**SMYRNA SCHOOL DISTRICT  
Smyrna Elementary School Renovations and Addition  
Bid Number SSD-15-001**

ADDENDUM NO. 2

23 March 2015

ARCHITECT'S PROJECT NO: 14107a

1 PARTIAL FLOOR PLAN - KITCHEN SERVICE PIPING  
P106 SCALE: 1/4"=1'-0"

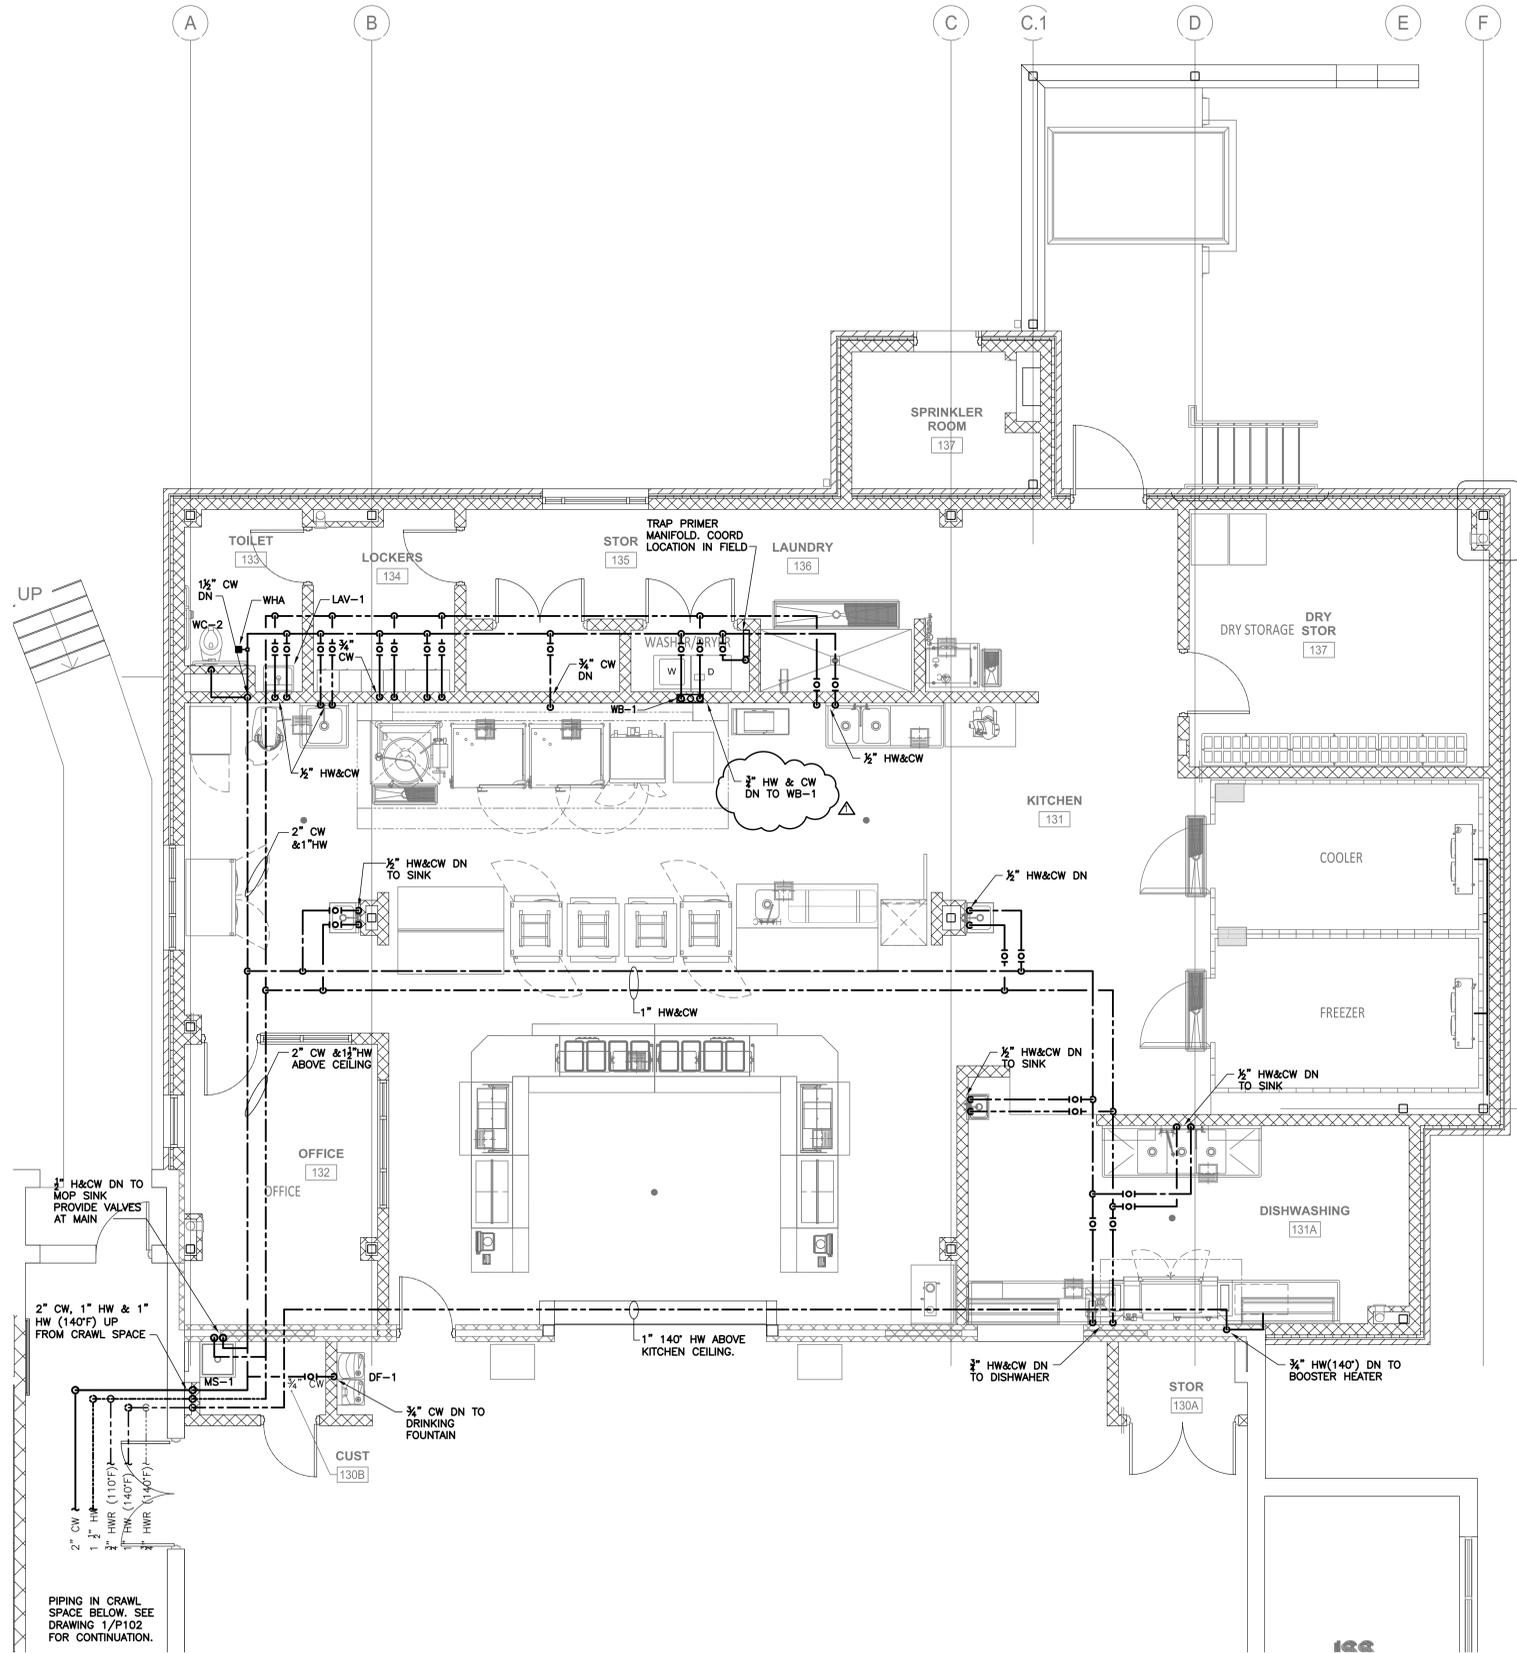
5. Under this Addendum, Food Service Equipment has been relocated and revised per Food Service Drawings FS-1 through FS-1.2. Electrical circuits and services to this equipment have not changed, but will be relocated to suit new equipment locations.

**DRAWING TITLE:**  
 FOODSERVICE PLAN AND SCHEDULE  
 DWN BY: CHK BY: PROJ NUMBER: 14107A  
 DATE: 03-16-15 DRAWING NUMBER:  
 SCALE: FS-1

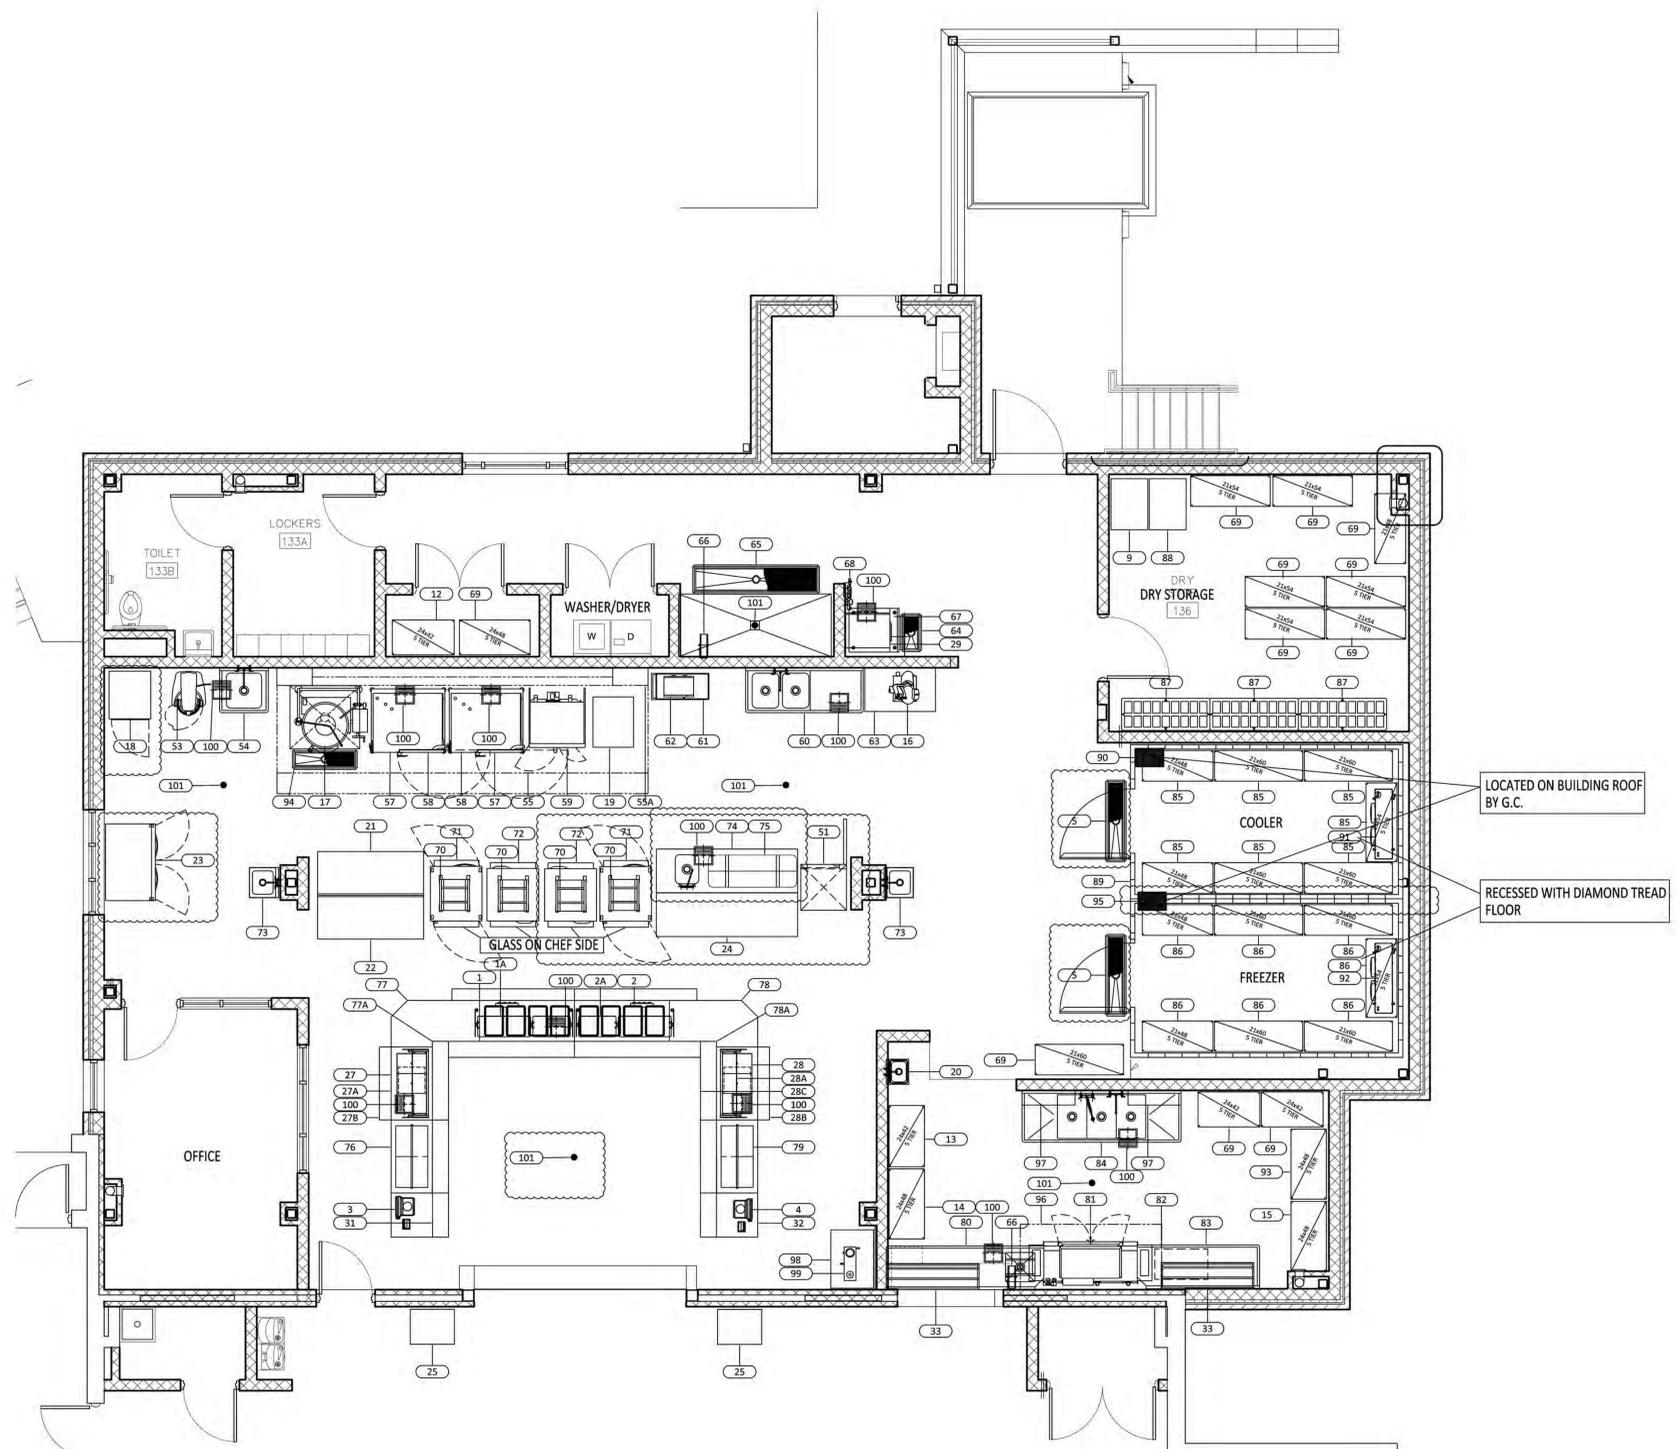
3.4 **CHANGES TO THE FOODSERVICE SPECIFICATION SECTION 114000:**

ADD THE FOLLOWING ITEM:

Item No: 5

Quantity: 2

Description: Floor Trough

Mfg: Eagle Group

Model No: FT-1254-SG

Sup Info: General contractor shall provide floor recess and install floor pan in recess flush with adjacent kitchen floor in a watertight manner.

- 4.1 Replace FS-1, FS-1.1 and FS-1.2 in their entirety, see attached pdf's.
- 4.2 Architectural drawings: ACODE-01, A11-01, A11-03 and A80-01. Under this Addendum, Food Service Equipment has been relocated and revised per Food Service Drawings FS-1 through FS-1.2. This revision does not change or alter location of walls. Graphic location of equipment shall be identical to attached drawing FS-1.
- 4.3 Replace MP001, M102, M103, M401, PD102, P102, P104, P105, P106, P109, P201, P302, FP101 & FP102 in their entirety, see attached pdf's.
- 4.4 DRAWING **E00-01**:
  - A. LEGEND AND ABBREVIATIONS: Add "WP" that denotes "Weatherproof".
  - B. PROJECT NOTES:
